**CITY OF BOULDER
PLANNING BOARD MEETING AGENDA**

DATE: February 6, 2014

CITY OF BOULDER
AGENDA ITEM PLANNING BOARD
MEETING DATE: February 6, 2014

CONCEPT PLAN REVIEW AND COMMENT: Request for public and Planning Board comment on a proposal for the redevelopment of 1750 14th Street. Proposed to include reuse of existing James Travel Building along with residential, commercial and office space.

Figure 11: Location of 100 year flood zone in relation to property

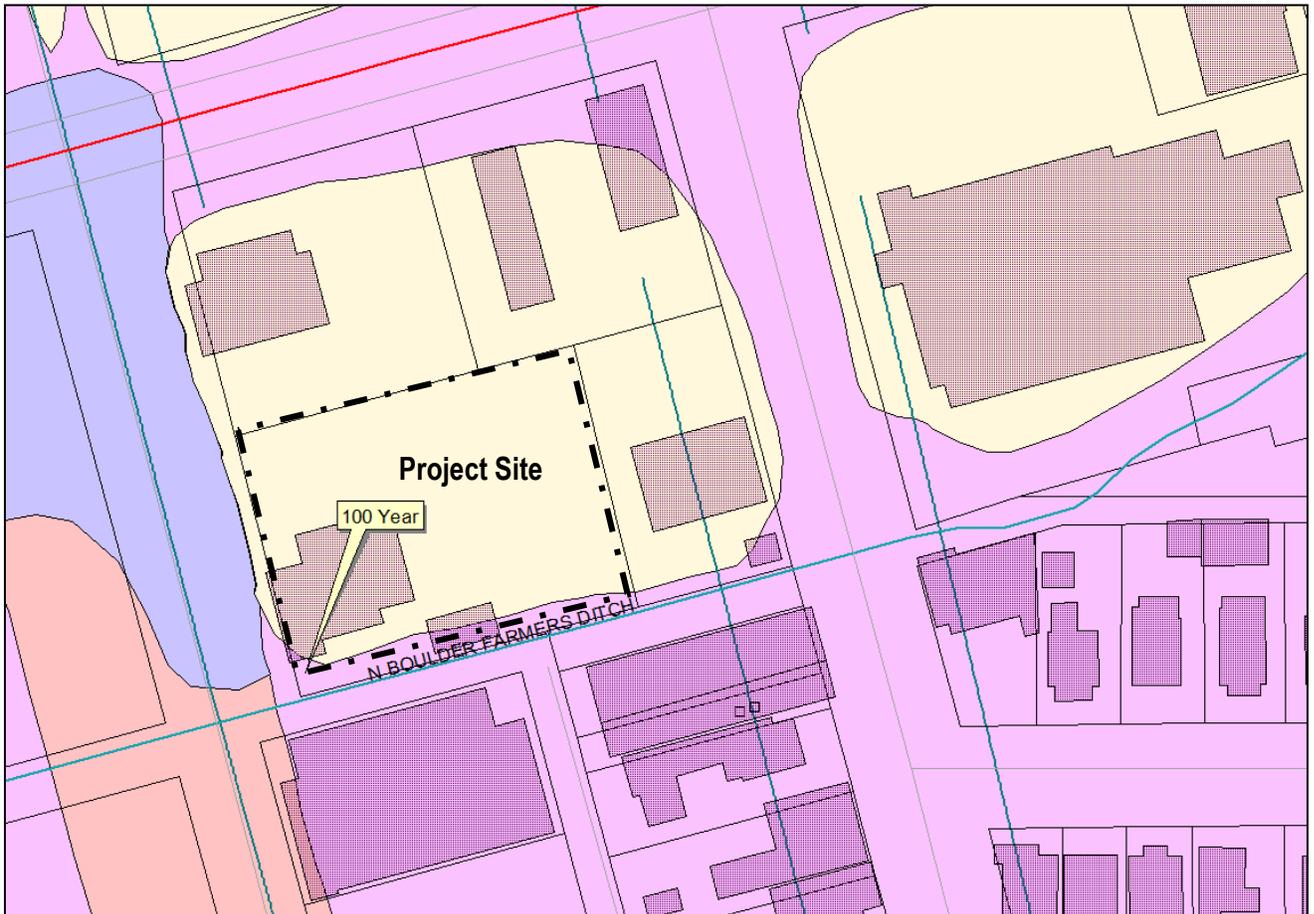
The property is located adjacent to the North Boulder Farmer's Ditch and a small area of 100 year flood zone is located on the property as shown in Figure 11. Because of the flood context, the site must be developed in compliance with Section 9-3-3 of the Boulder Revised Code, 1981 (*BRC*). A floodplain development permit demonstrating compliance with floodplain development regulations will be required at the time of building permit. The City of Boulder has adopted modifications to the floodplain development regulations which will become effective on March 1, 2014. The revisions include a clarification of the standards for development of a mixed use structure. The ordinance will require that any person making a substantial modification or a substantial improvement to an existing mixed-use structure shall flood proof or elevate the lowest floor, including the basement of the entire structure and shall elevate all residential and lodging units within the structure to or above the flood protection elevation.

Other environmental considerations include a number of existing trees that align the ditch that such as box elder and willow, that should be preserved with any extension of the multi-use path. There are also existing established oak trees along the street frontage on 14th Street that are valued as a species and should be preserved. Refer to the Landscape comments regarding preservation of on-and off-site trees near the area planned for construction.

Figure 15: Aerial illustrating mass and scale of site and surroundings with zoning in context

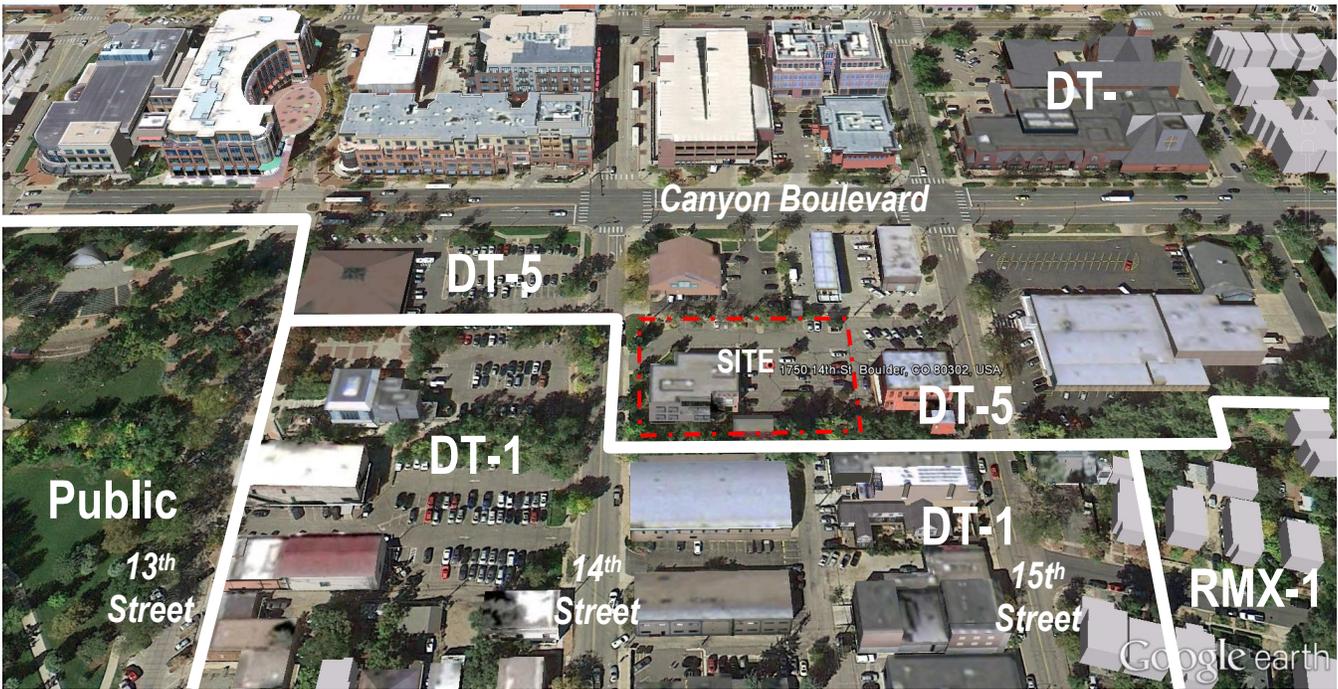
As shown in the aerial presented in Figure 15, the proposed four story structure would not be atypical for the surroundings, particularly those to the north and across Canyon Boulevard, where recent redevelopment within the DT-5 zoning has been built to four stories and 55 feet. As can be noted in the aerial, to the south of the site is area zoned as DT-1. As can also be seen in Figure 15, the areas immediately surrounding the site on the west, north and east are also within the DT-5

zoning and, given that they are currently not built to maximum DT-5 standards, they are somewhat underutilized. However, the lower intensity DT-1 and lower density RMX-1 are located to the south and southeast of the site. While the by-right number of stories for DT-1 is two stories, and 38 feet. The zoning does establish a gradient of intensity and transition in this location.

Figure 3:
**Proposed East Elevation of the Building Placed into the Existing Context
 Looking West from 15th Street with Historic McAllister Building in Foreground**

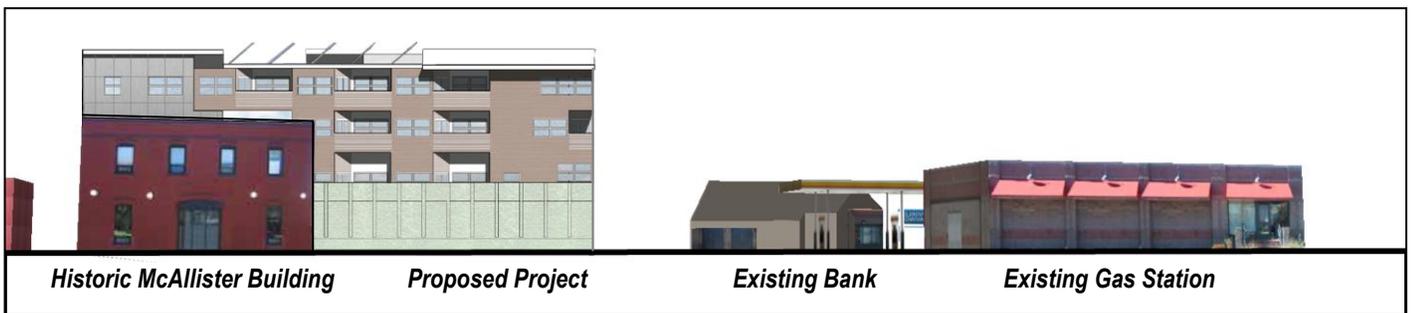
- g. To a similar extent, the views of the building from the east, along 15th Street as shown below in Figure 3 will also be pronounced in the interim prior to redevelopment of the adjacent properties. Precedent images of how the green walls will be implemented would be helpful in understanding the appearance of the building during the period of time from the existing context to the future redevelopment of the surroundings.

Figure 5: Location of 100 year flood zone in relation to property

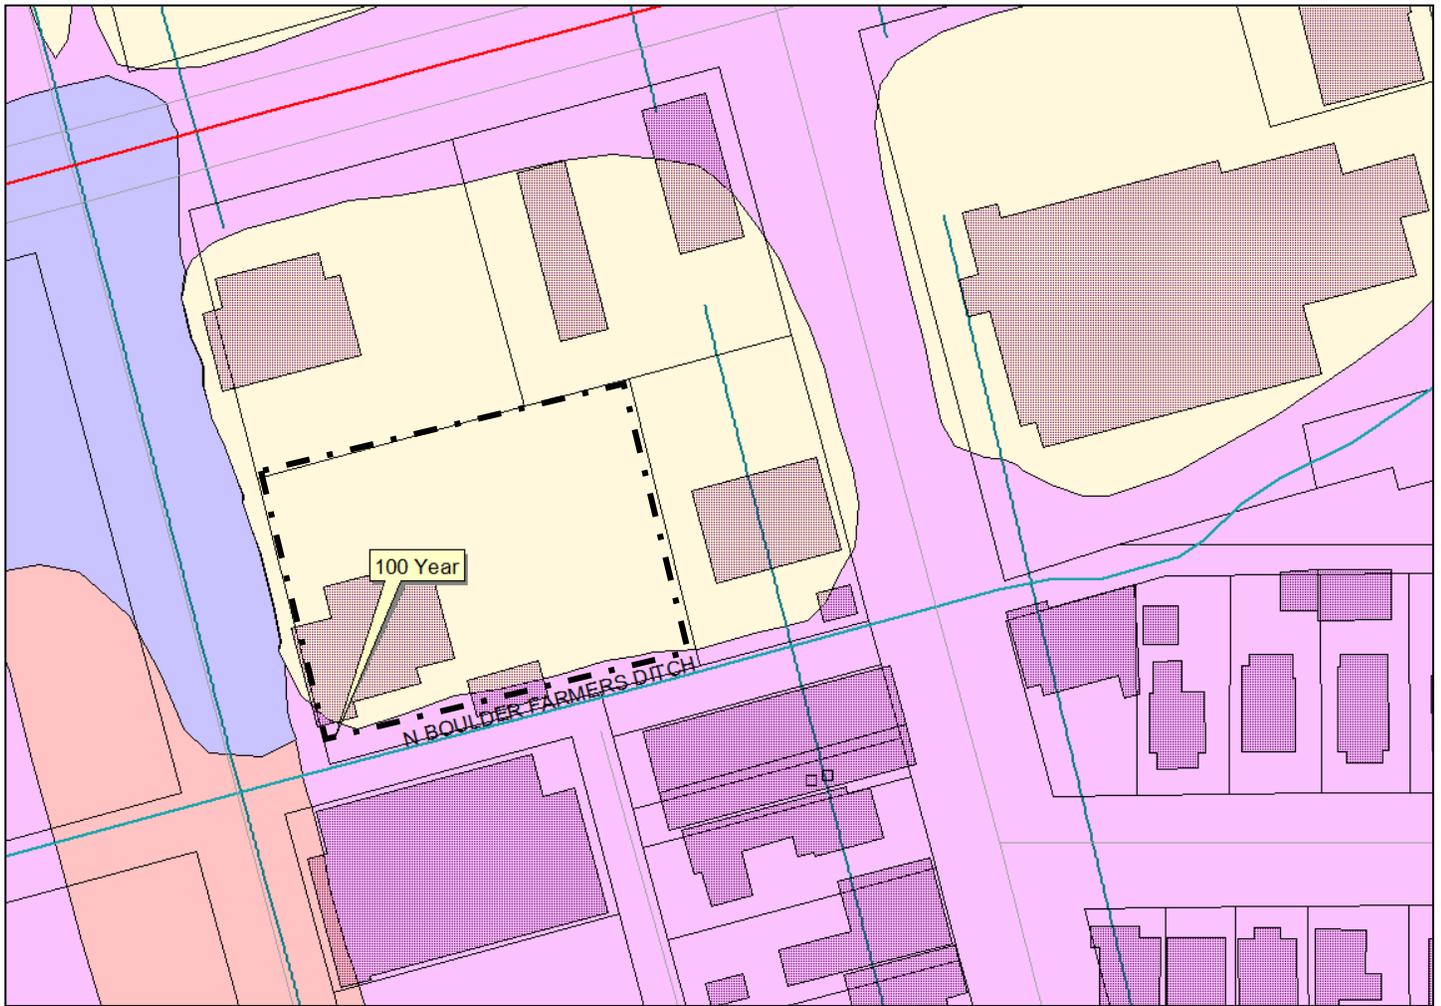
The property is located adjacent to the North Boulder Farmer's Ditch and a small area of 100 year flood zone is located on the property as shown in Figure 5. Reference the Flood Control comments regarding mitigations for locating within the 100-year flood zone.

There's a number of existing trees that align the ditch that include Boxelder and Willow that should be preserved with any extension of the multi-use path. There are also existing established oak trees along the street frontage on 14th Street that are valued as a species and should be preserved. Refer to the Landscape comments regarding preservation of on-and off-site trees near the area planned for construction.
